| Project | IEEE 802.16 Broadband Wireless Access Working Group < http://ieee802.org/16 > |
| Title | Proposed Text related to Downlink Power Control for Femtocell BS for the IEEE802.16m/D2 (15.4.12.1) |
| Re: | LB comment to 802.16m Amendment Working Document D2 |

Fig.1: DL Maximum transmit power setting compensated by penetration loss

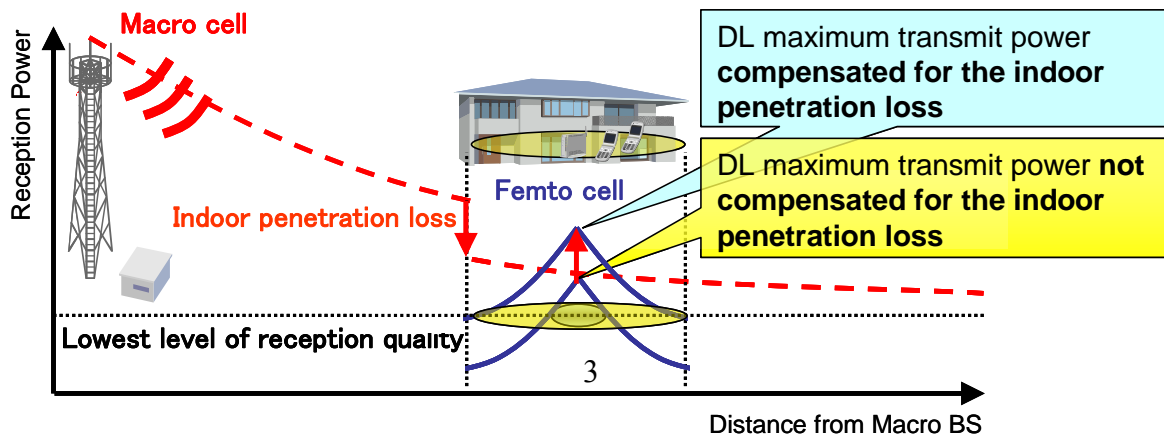
In equation (2), the penetration loss is estimated and the power offset shall take this value into account. For buildings with small penetration loss such as 1 or 2 stories residential houses, the transmit power becomes small so that the interference to macro/micro cell can be mitigated. For buildings with large penetration loss such as an office building, the transmit power becomes large so that the indoor communication quality can be high. Fig1 shows the indoor communication quality becomes high because the transmit power is compensated by the penetration loss.

Fig.2 Dependence of Cell Throughput on P_{offset_o}

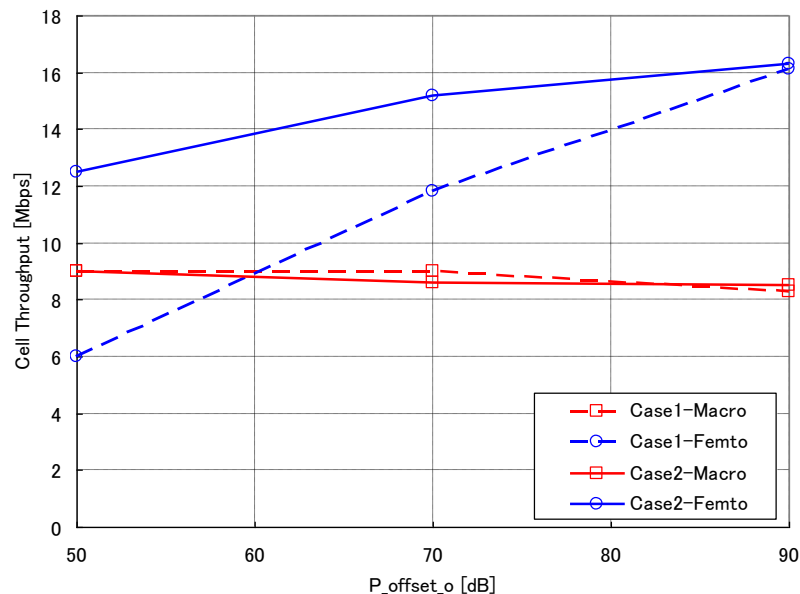
Fig.2 shows dependence of Cell Throughput on P_{offset_o} . According to Fig.2, the difference of Cell Throughput of macro cell between Case1 and Case2 is negligible. Both cases degrade by about 7% at $P_{\text{offset}_o}=90$ dB. Therefore we focus our analysis on two cases at $P_{\text{offset}_o}=50$ or 70 dB because it is important to keep Cell Throughput of macro cell without increasing interference from Femtocell to macro cell. Cell Throughput of Femtocell in Case2 is much higher than that in Case1 by 29% at $P_{\text{offset}_o}=70$ dB and 108% at $P_{\text{offset}_o}=50$ dB respectively. This is significant enhancement of the network due to the large gain in the femtocell environment.

Fig.3 Dependence of Achievement Ratio of Peak Rate on P_offset_o

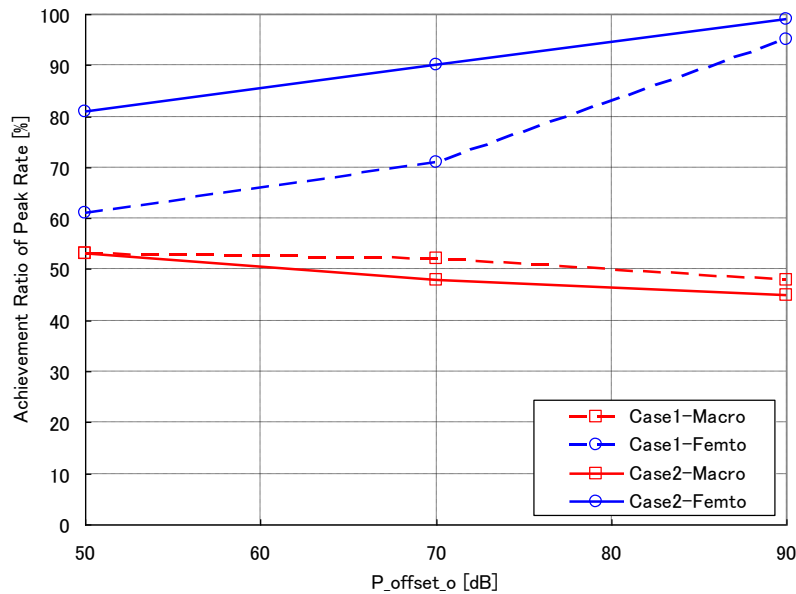
Fig.3 shows dependence of Achievement Ratio of Peak Rate on P_{offset_o} . According to Fig.3, difference of Achievement Ratio of Peak Rate of macro cell between Case1 and Case2 is small and both cases are degraded by about 12% at $P_{\text{offset}_o}=90$ dB. Therefore we focus our analysis on the two cases at $P_{\text{offset}_o}=50$ or 70

dB. Achievement Ratio of Peak Rate of Femtocell in Case2 is higher than that in Case1 by 27% at P_offset_o=70 dB and 33% at P_offset_o=50 dB respectively.
